**STAFF RECOMMENDATION**

**922 Montrose Avenue**

**April 22, 2020**

**Application:** New Construction—Addition

Figure 1. 922 Montrose Avenue.

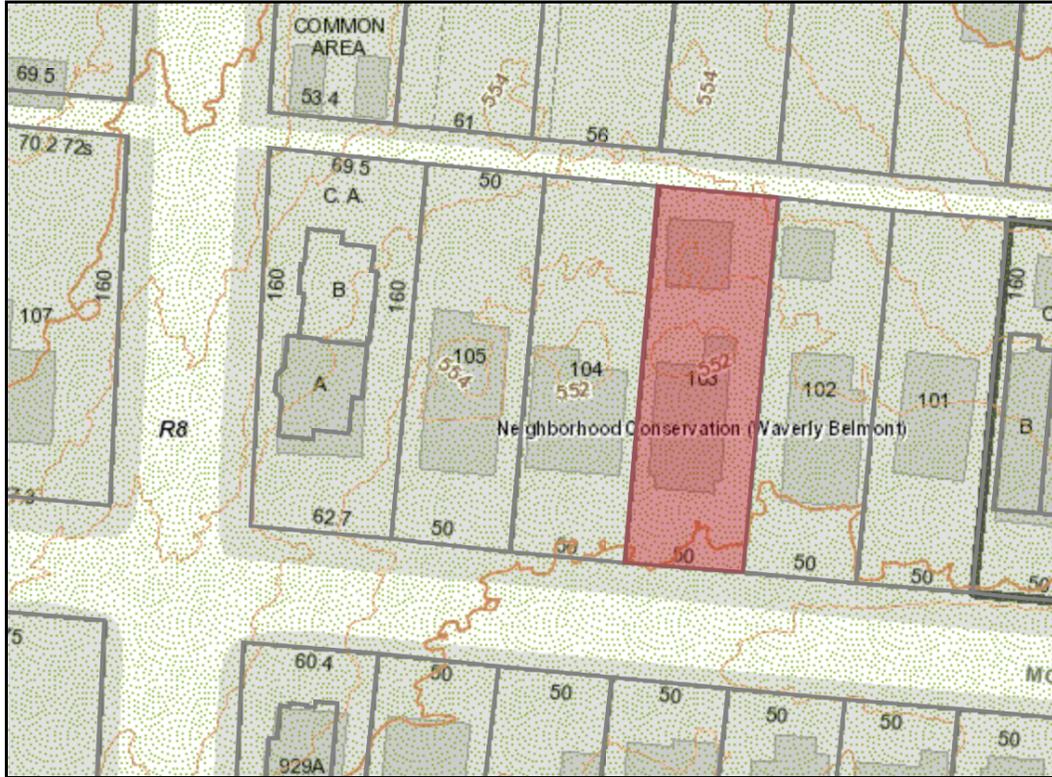
**Background:** The house located at 922 Montrose Avenue is a c. 1914 frame bungalow that contributes to the historic character of the Waverly Belmont neighborhood (Figure 1).

Figure 2. Proposed left-side façade.

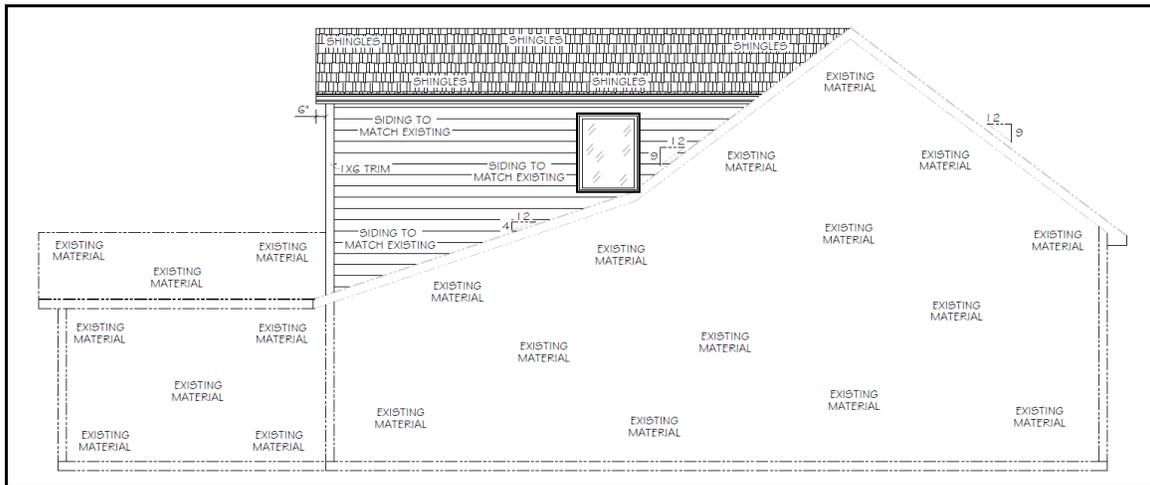
The windows on the proposed addition are all generally twice as tall as they are wide, thereby meeting the historic proportions of openings. There are no large expanses of wall space without a window or door opening. However, the window on the left-side façade appears to encroach into the existing roof plane of the historic house, which is not appropriate (Figure 2). Staff would recommend shifting the window to left to avoid this scenario.

With the condition that the window on the left-side façade not encroach into the eave of the historic house, staff finds the project’s proportion and rhythm of openings can meet Section III.G. for new construction-proportion and rhythm of openings.

1. The addition shall be set in two feet (2') from the side wall;
2. The cladding material for the addition shall meet the design guidelines; and
3. The window on the left-side façade shall not encroach into the eave of the historic house.

REAR ELEVATION

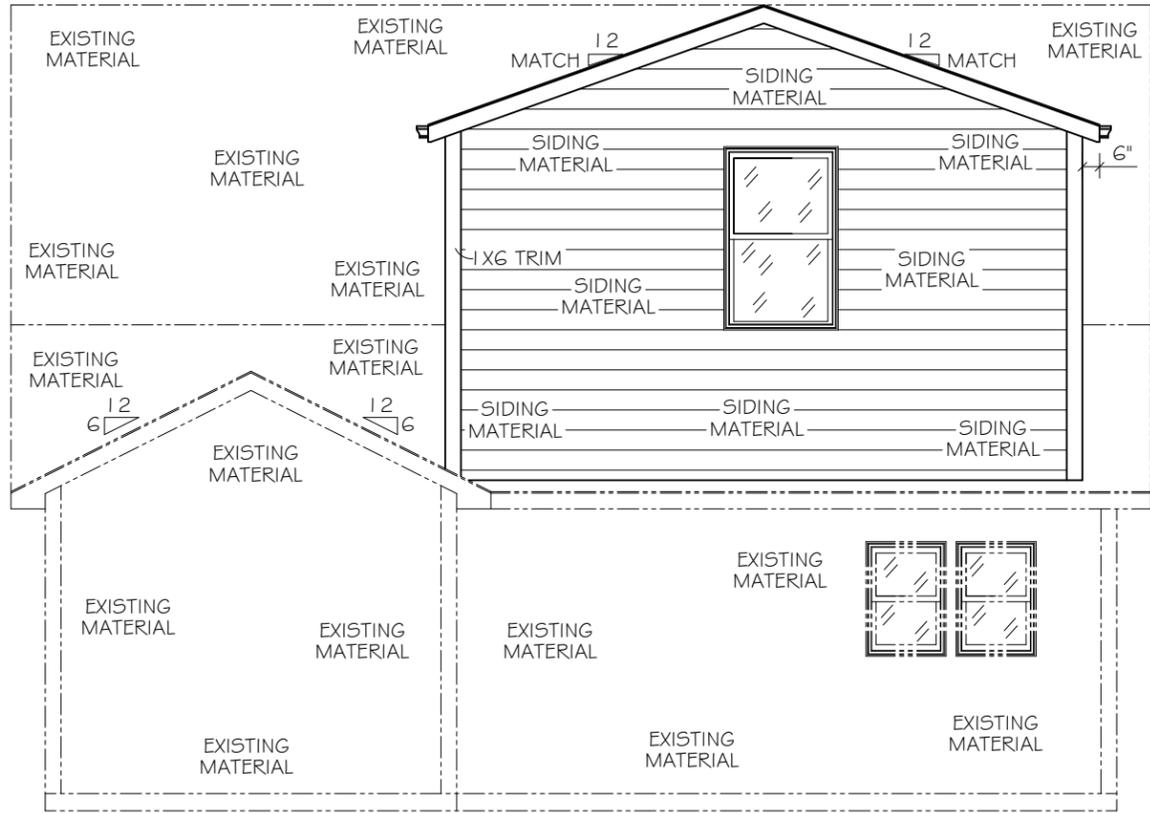
**Proportion and Rhythm of Openings:** The plan includes adding paired windows on the existing rear elevation. All paired windows must have four to six-inch (4” – 6”) mullions between them, and windows within clapboard walls must have four inch (4”) casings. The proposed paired windows on the rear façade do not include the required mullion.
